Seismic Walkdown Checklist (SWC) SWEL1- 089

Equipment ID No. EJ-1051 Equip. Class¹ 20, INSTRUMENTATION AND CONTROL PANELS

Equipment Description AUX FEEDWATER CONTROLS

Location: Bldg. AUX Floor El. 607 Room, Area 223

Note: Angle connection top tube steel bracing supports non-conformance.

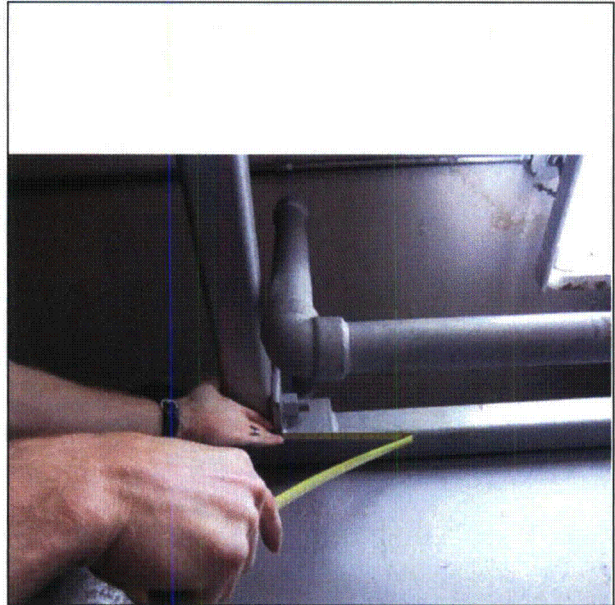
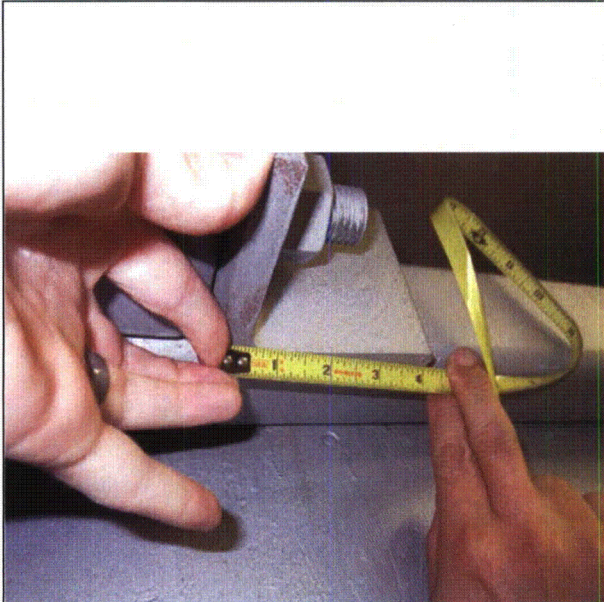
The anchorage configuration is consistent with plant drawing C-103, Sh. 2B, Rev. 1 with the exception of the angle connecting the tube steel at the top brace. The angle is a 4x4x0'-4"x1/2" and drawing C-103 calls for a 5x3x0'-4"x1/2" angle. Licensing basis evaluation, LB-02, has been created. CR-PLP-2012-6565 has been initiated.

Note: *Lighting Fixture Suspended by open S-Hook*

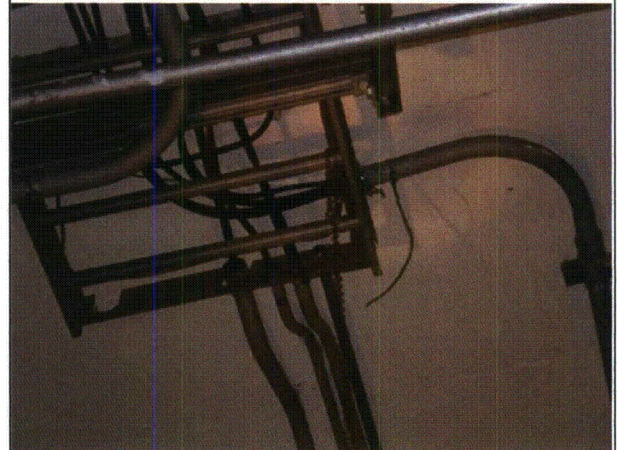
Note: *Loose Uncrimped S-Hook Hanging From Cable Tray*

Note: Spring Can with Bent Hanger Rod

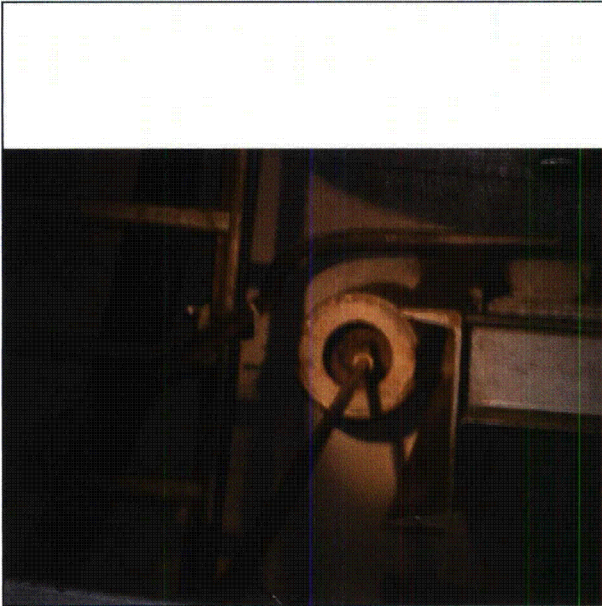
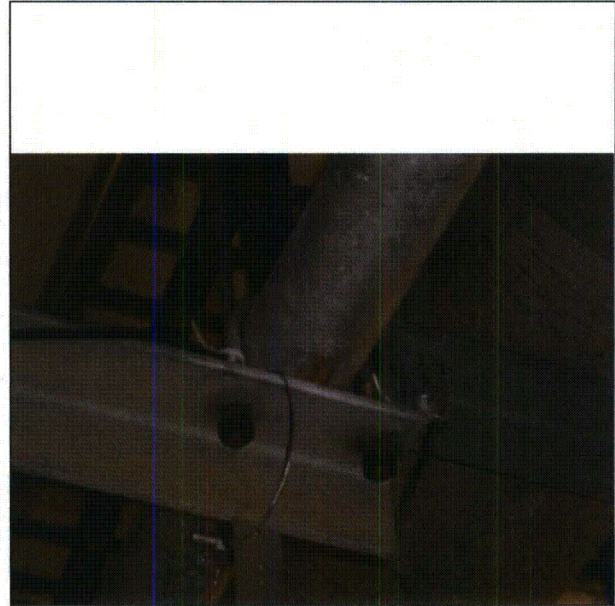
Note: Pipe Lifted Off Support

Note: Bent Hanger Rod with Sliding Clamp

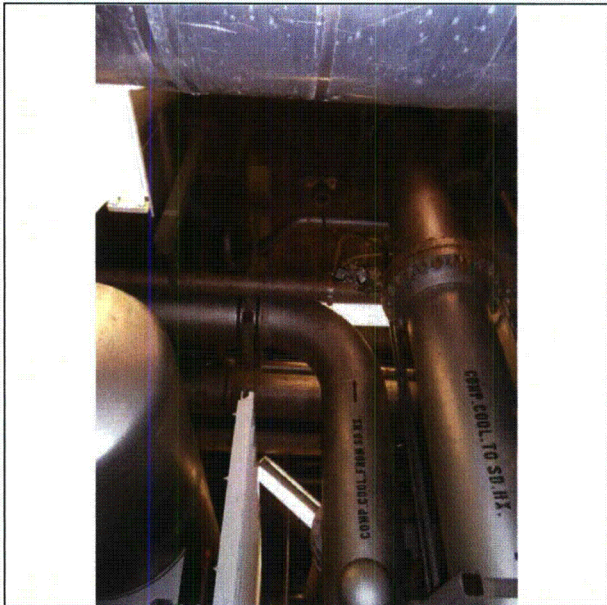
Note: Pipe Hanger Supported by Spring Cannister Bent Around Pipe (Overview)
